21/04625/FUL | Change of use from agricultural land for the construction of an A10 bridge structure with associated earthworks embankment bridge landing, construction of a shared use route for non-motorised users between the Waterbeach Barracks site and Green End including a 3m shared footway cycleway and 2m grassed verge for equestrians and 1m grassed verge, hard and soft landscaping, lighting, construction compound and temporary haul roads | Land Between Green End And The Waterbeach Barracks Site Waterbeach Cambridge Cambridgeshire CB25 9PA

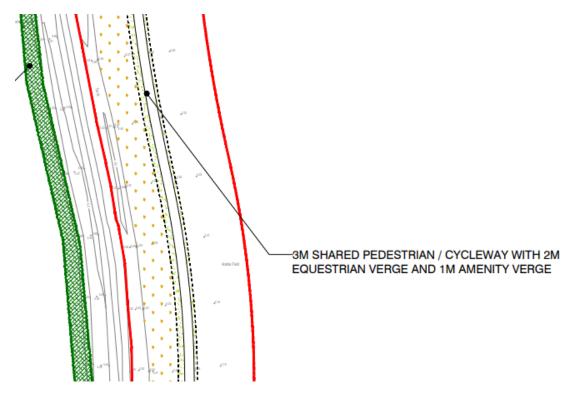
Much of the Mere Way cycle link does not require planning permission as it is described as 'transportation works within the highway' this is identified blue on the attached inset plan which extends down Mere Way under the A14 and into the Cambridge Science Park.
